# Letters to the Editor

## A New Antenna Model (Jul/Aug 2012)

Figure 4D — This is the corrected version of Figure 4D from “A New Antenna Model,” Jul/Aug 2012 QEX, p 10. Note that the SWR scale along the left edge of the graph has been corrected to show an SWR of 1 at the bottom of the graph.

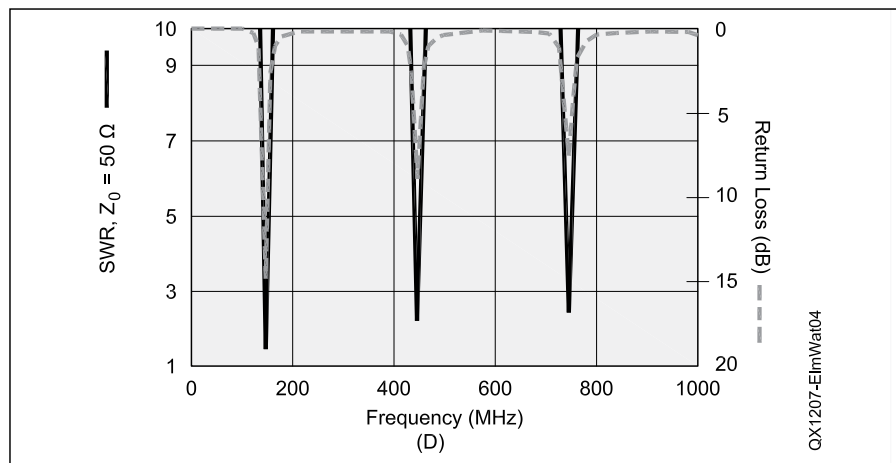
Is Figure 4D (all the way down) on page 10 (SWR and Return Loss), is the vertical axis correct? I think RL is defined as:  $RL = -20 \log SWR + 1 / SWR - 1$

So it appears to me to be somehow shifted on the right vertical axis.

On the left axis, SWR should not start at  $SWR = 0$  but  $SWR = 1$ .

No, you're not missing something, it's wrong. Thanks for the catch!

During graphics layout for publication in *QEX* the left axis got re-labeled. As published, Figure 4D has an SWR less than unity shown at the bottom of the left axis and some of the data seems to go down there! If we can perfect this, it might be useful for negative noise figure receivers! In fact, the axis should have been labeled 1 to 10 rather than 0 to 10 as published.
